Final Drainage Report

# Eagleview Subdivision El Paso County, Colorado

Prepared: December 23, 2022

Please add PCD File  
# SF-22-42

## West Tributary – Existing Conditions

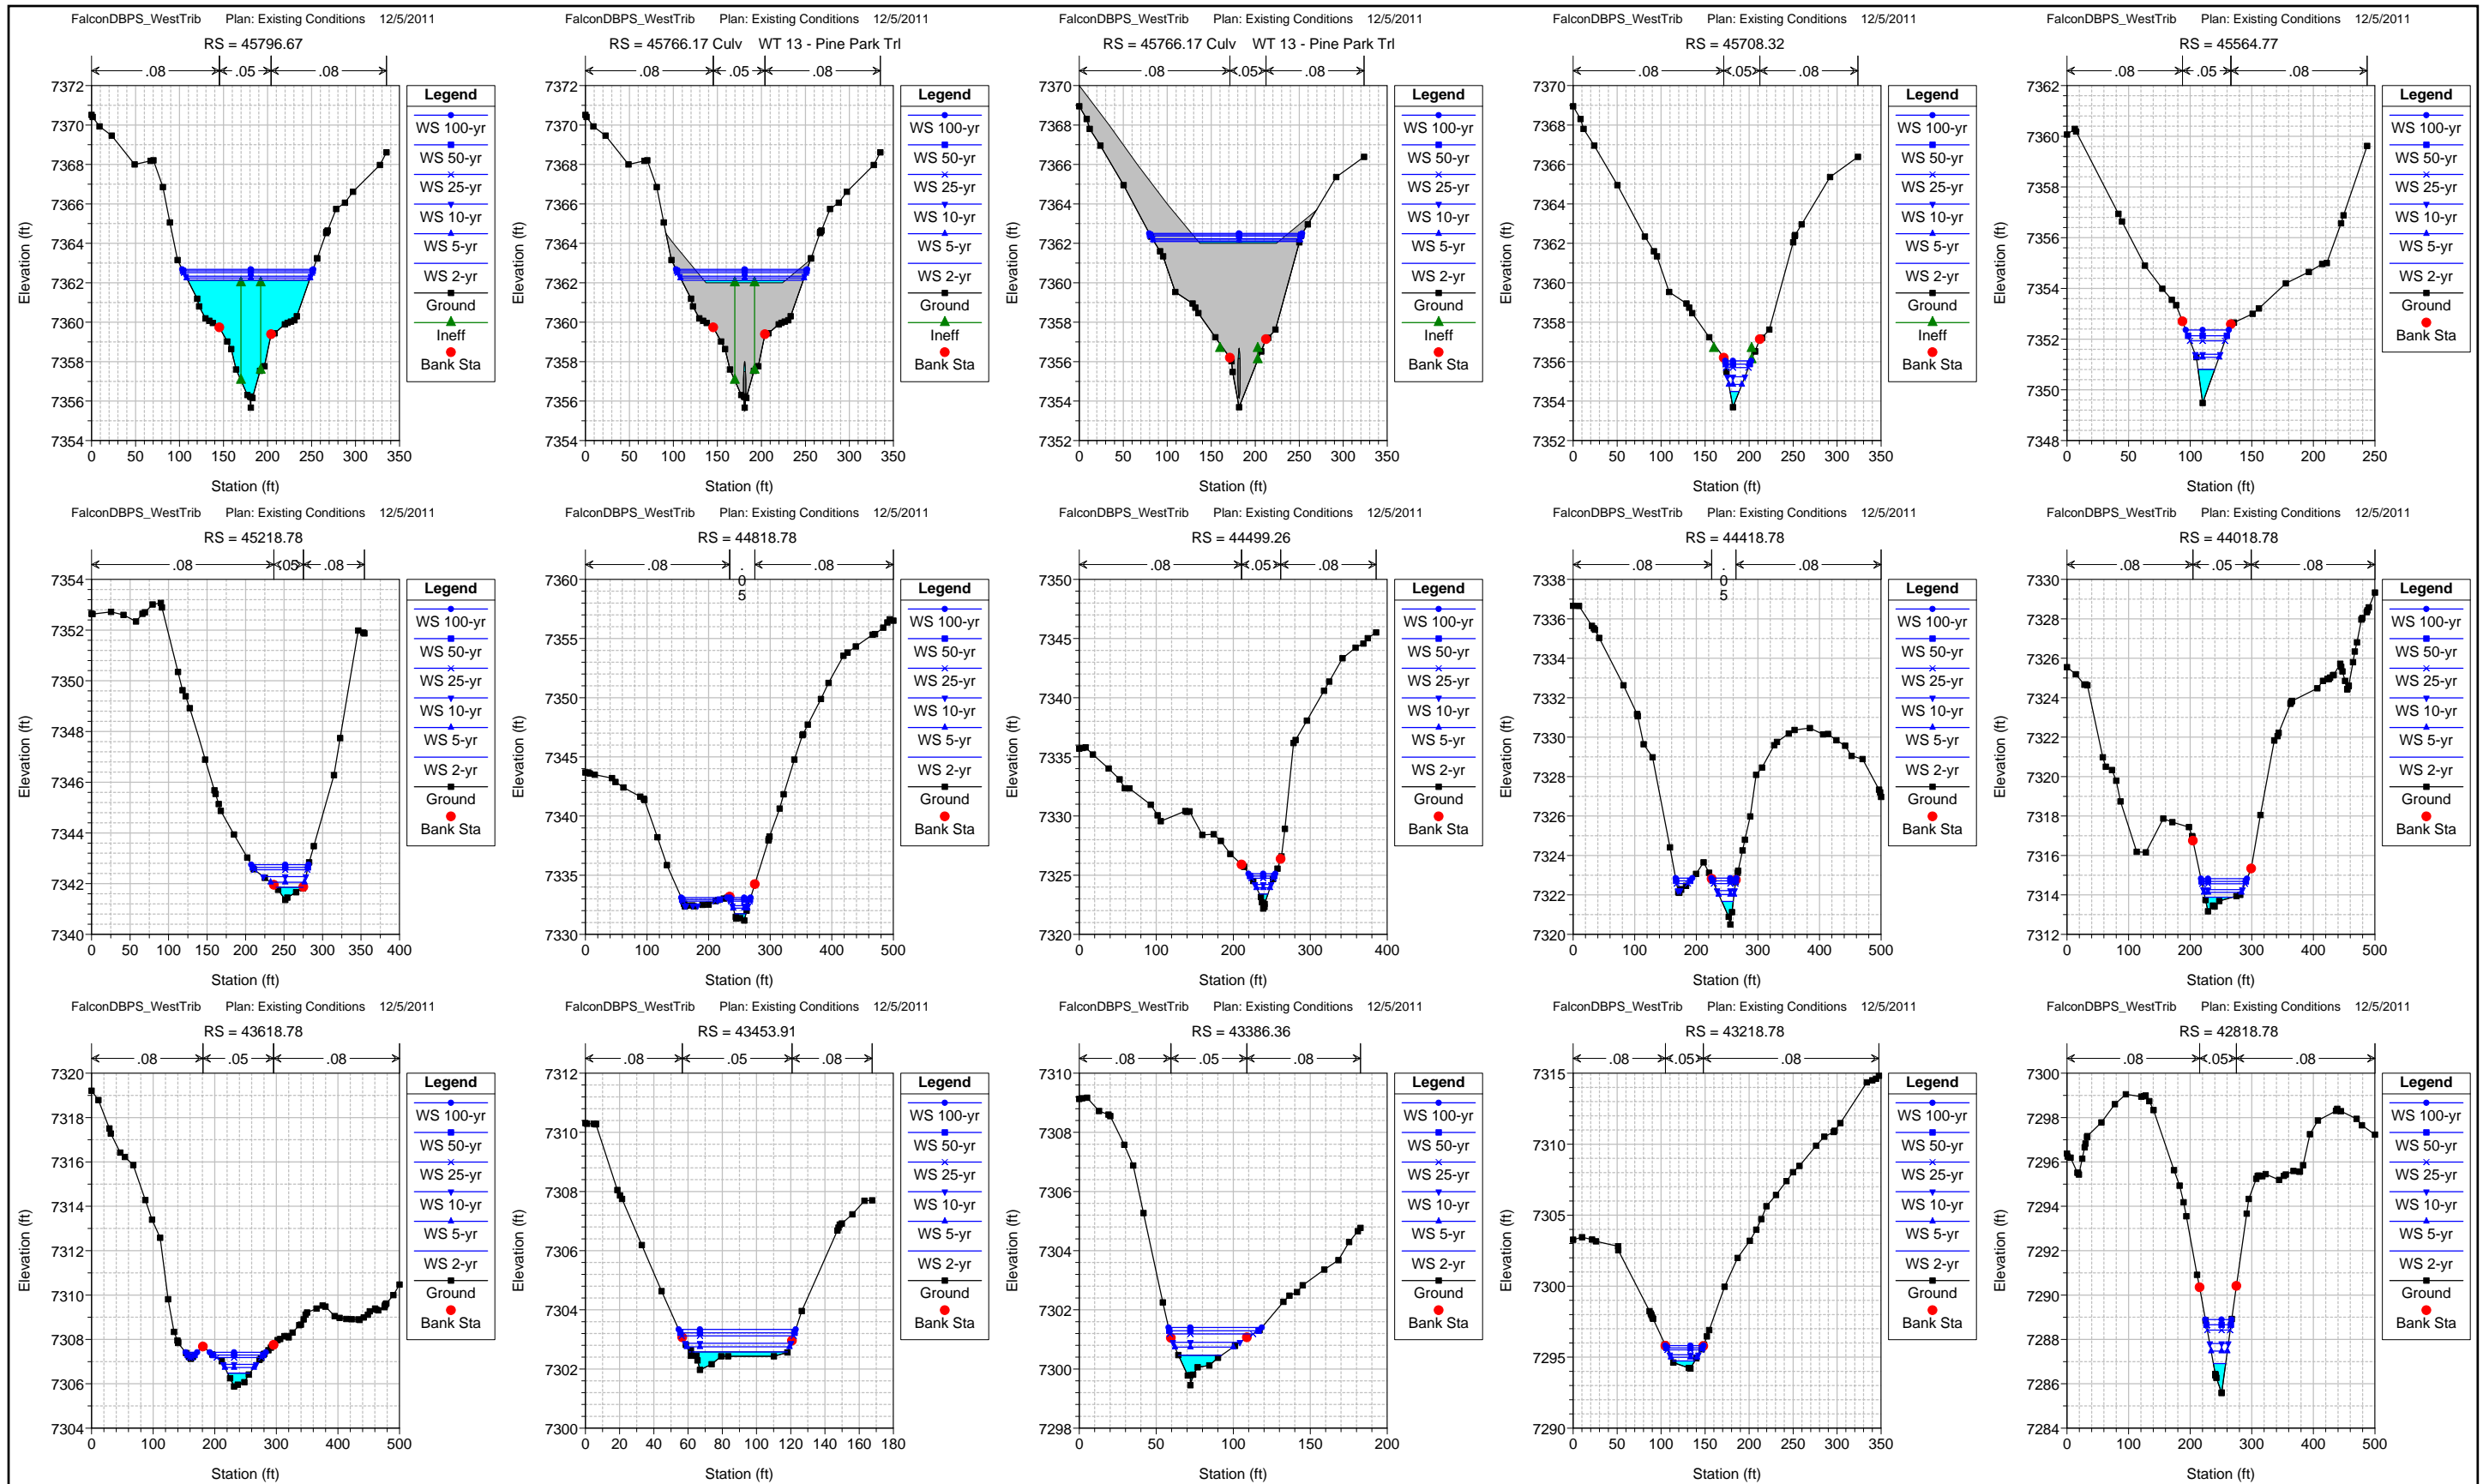
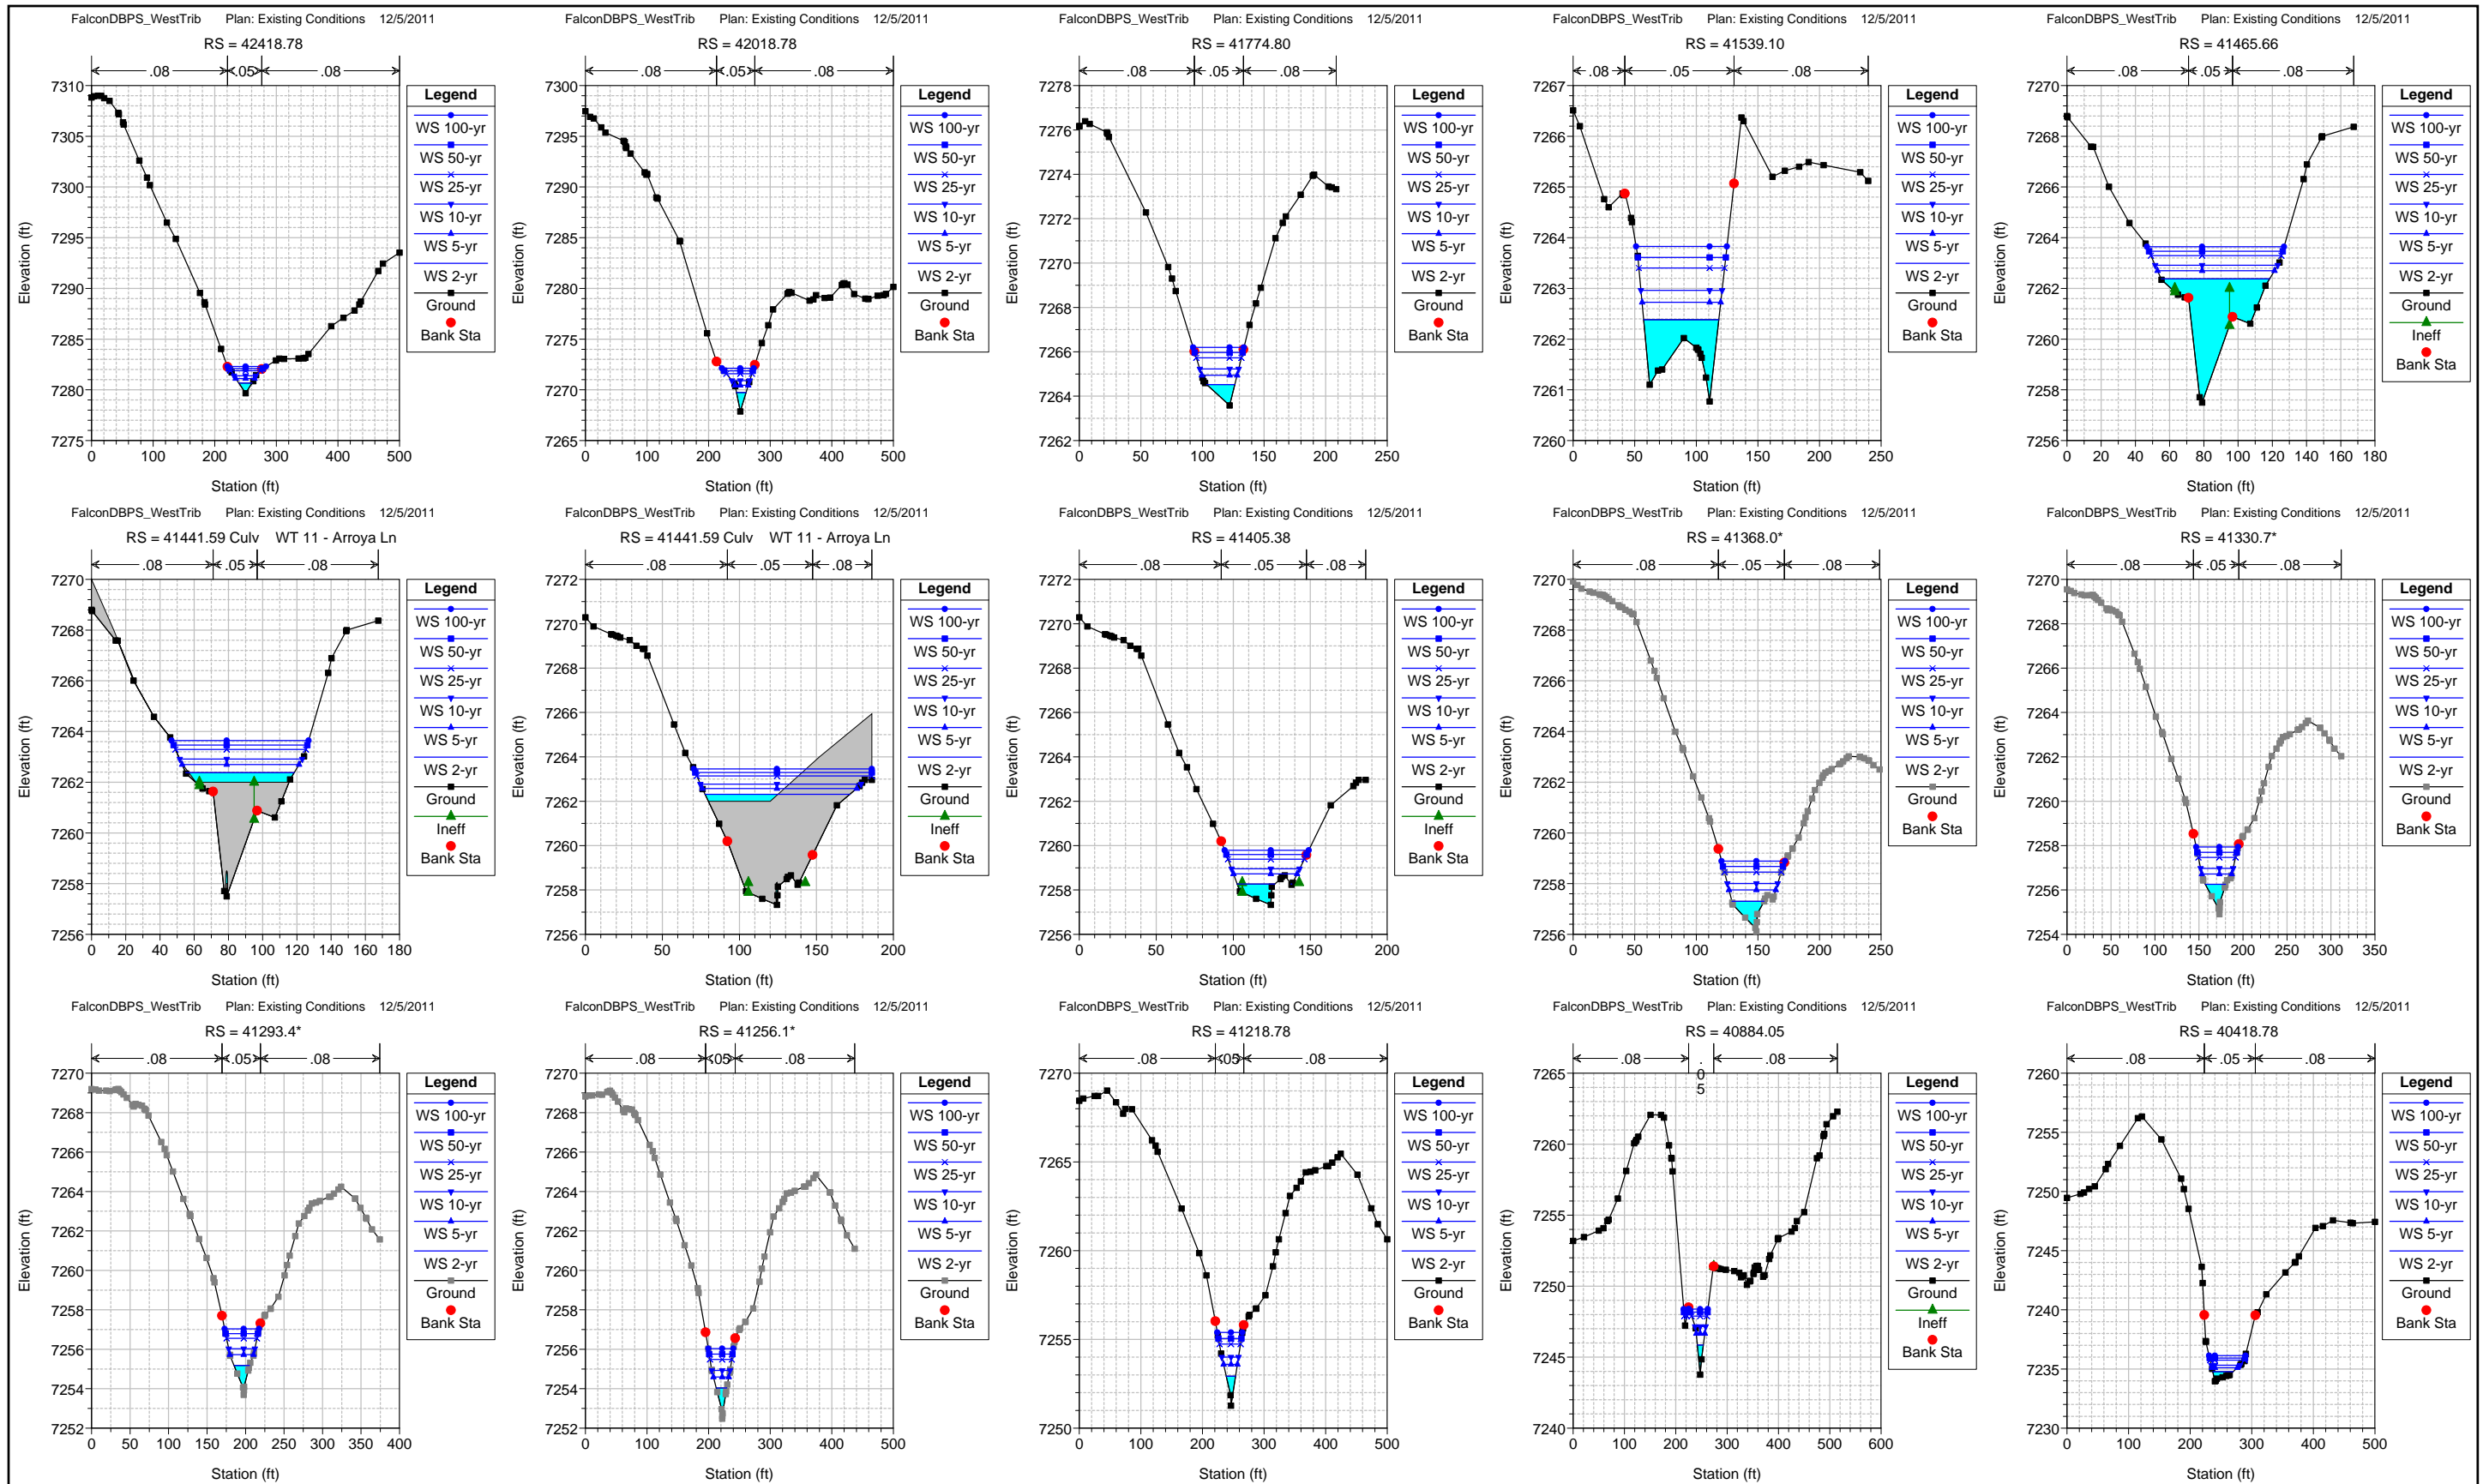
Provide an existing and proposed HEC-RAS Map showing the cross section cuts.

Contact the review engineer to discuss. Is the HEC-RAS included from the DBPS? Is there going to be a separate modeling specific to the proposed improvements?

Not clear why this is included in the report. It seems this can be removed.
